工程指示 / 要求簡箋(E.I.)

工程指示編號：EI/8282/24 修改版次：-  
 工程編號：J - 858 工程名稱：將軍澳日出康城 11  
 工程項目：T1-T3 特色層後裝窗 5 隻 改拆圖 和查料 (先查鋁料倉存)  
 收件人：生統 / 拆圖 發件人：Ant Yeung 日期：03/09/2024

Re: Design, Supply & Installation of Curtain Wall, Glass Wall, Aluminium Window, Aluminum Cladding & Louvers at T.K.O.T.L 70 RP, Phase 11, LOHAS Park, Tseung Kwan O, N.T.

有關特色層 5 隻廚房窗改動 (小型工程) 事宜:

DWG NO. : J858-IW-2103b REV. : E

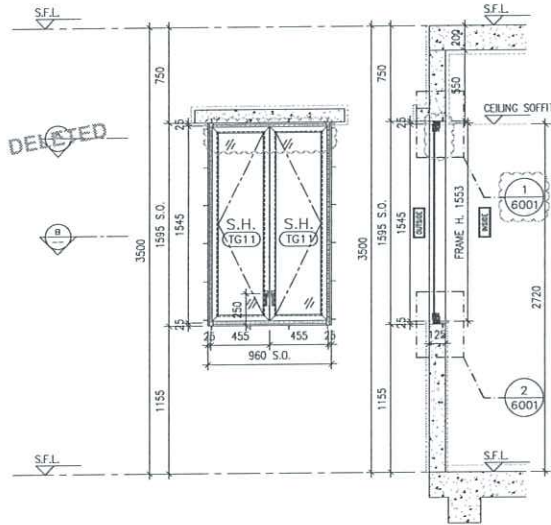
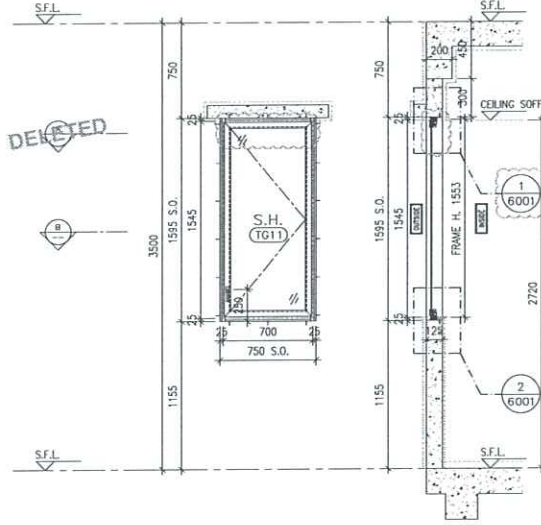
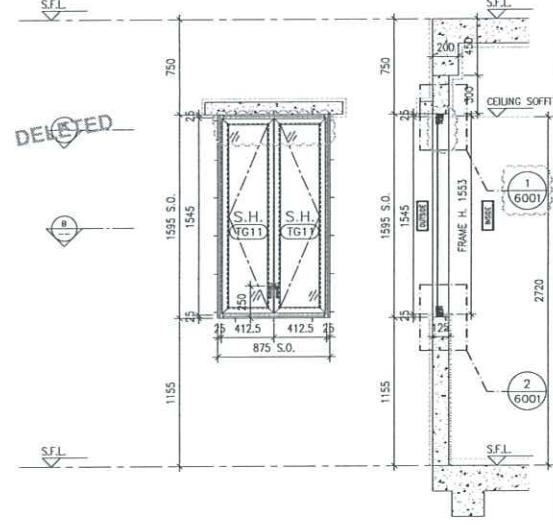
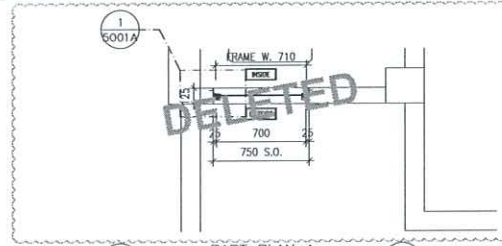
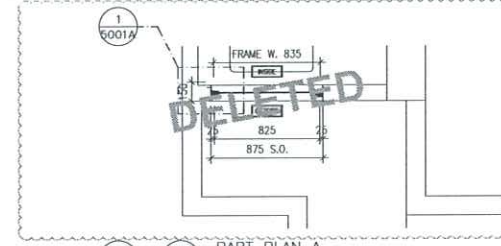
按業主要求，重新生產 5 隻特色層廚房窗。  
請再查 J858 鋁料倉存。確認有足夠鋁料生產。

T1 BB K-1, T2 BB K-1, T3 BB K-1  
T2 AF K-1, T3 AF K-1

驗樓後，貴司要求，此特色層 5 隻廚房窗需要改為全高的窗玉(不要梗玻璃)。涉及額外工作和報廢物料(鋁料、玻璃等)。改動將以驗樓之後小型工程(A and A Works)進行。圖紙見附件 3 *打差收*

請貴司發出正式 A.I 確認改動。重新生產 5 隻特色層廚房窗，報廢現場 5 隻窗及拆百葉改安玻璃。稍後報價另外附上。請貴司確認報價，方便本司安排人手跟進。
